Re: Department of Buildings Zoning Approval for 200 Amsterdam Avenue, Manhattan

Zoning Challenge
and Appeal Form
(for approved applications)

RE: Zoning Challenge 200 Amsterdam
Block 1158, Lot: 133, Job No:
122887224, Doc. 7

*Areas covered by the 1987 zoning lot classified by use of land (with 200 Amsterdam shown as constructed).
Gerrymandered zoning lot of 200 Amsterdam and 200 West End Avenue shown in red*

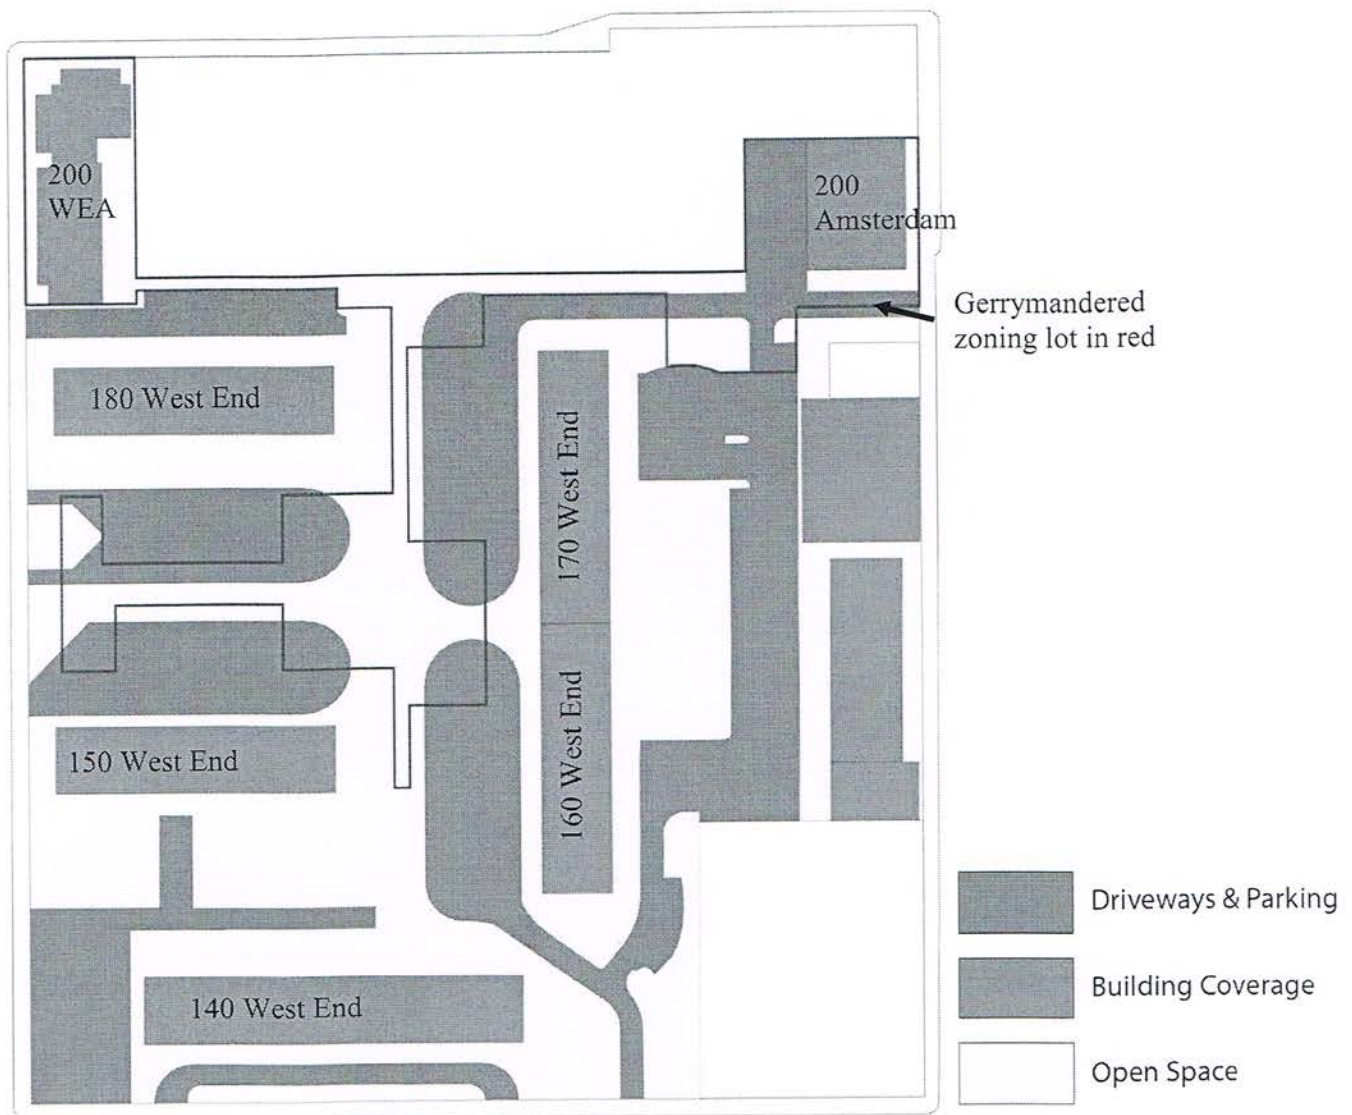
As stated in the Zoning Resolution, up to 50% of the required open space may be accessory parking, driveways, loading docks and bike parking. These uses are shown in gray above.

By my office's calculations, 33,983 SF of the open space on the gerrymandered lot is used for driveways and parking. According to 12-10, an Accessory use:

The parking and driveways are accessory to the uses on the Lincoln Towers zoning lot. They are not accessory to the uses on the gerrymandered lot since there is no parking provided for 200 Amsterdam or 200 West End Avenue. Uses accessory to another zoning lot are not permitted obstructions in Open Space, and thus, the 33,983 SF cannot be counted as open space in 200 Amsterdam's zoning calculations.

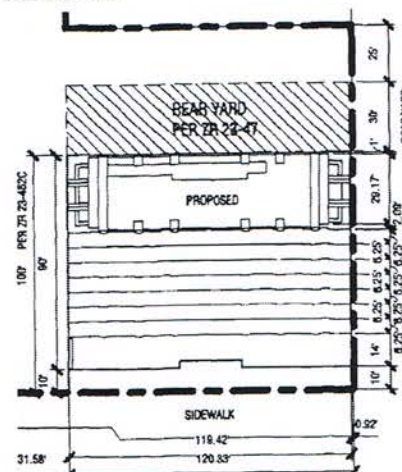
The proposed rear yard of 200 Amsterdam from the ZD1 is shown to the right. It is used as parking that is accessory to Lincoln Towers. As was stated earlier in this letter, an accessory use, "is a use conducted on the same zoning lot as the principal use to which it is related." Consequently, the proposed rear yard does not comply with 23-44.

The sky exposure plane proposed for 200 Amsterdam. The top four floors break the sky exposure plane.

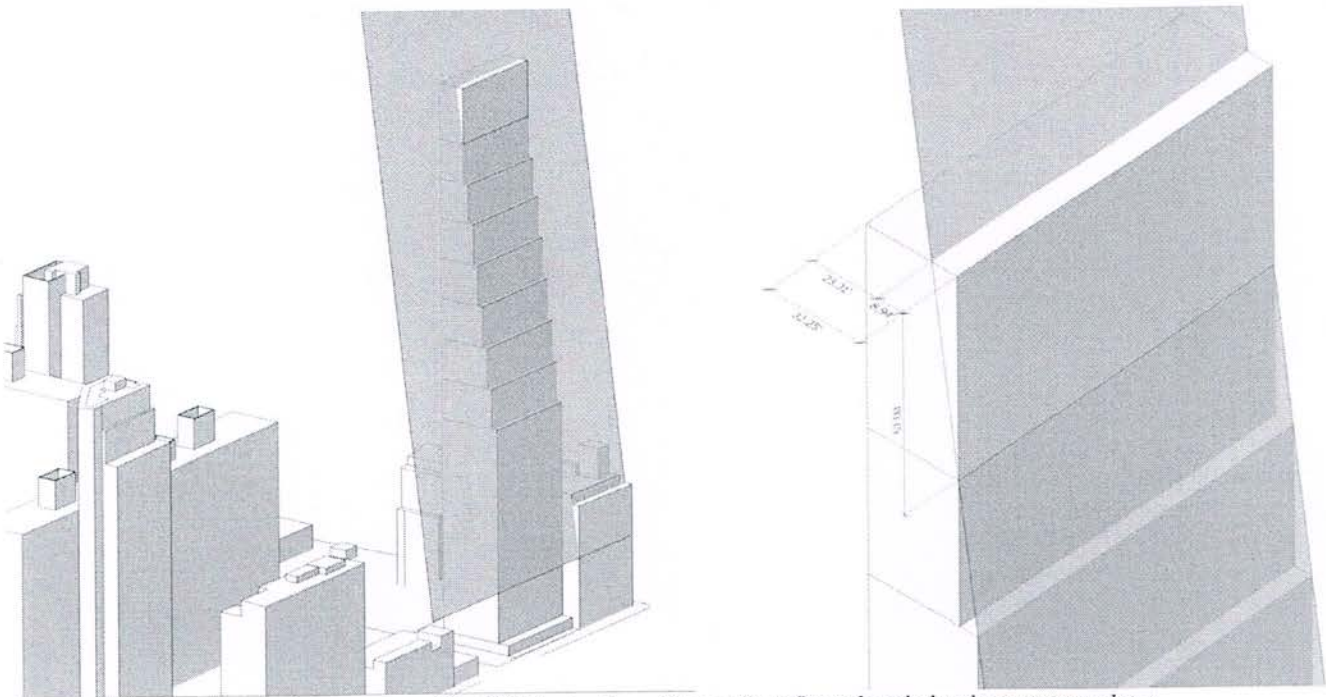
The building pierces the sky exposure plane as defined by 23-642

The top four floors of the building contain building mechanicals. No mechanicals are placed on the roof. The ZD1 shows that these four floors pierce the sky exposure plane, treating them as a permitted obstruction.

The ZD1 states, in effect, that the mechanical equipment located in floors 51 through 55 are permitted obstructions under 23-62(g). The question as to if the in-building mechanical floors may penetrate the sky exposure plane as a permitted obstruction hangs on the definition of "enclosures." Unfortunately, this is not a defined term in the Zoning Resolution, but the applicant claims, and the Department has agreed, that enclosures may mean exterior building walls. This interpretation is in error, however, as it is not consistent with the New York State Multiple Dwelling Law (MDL).
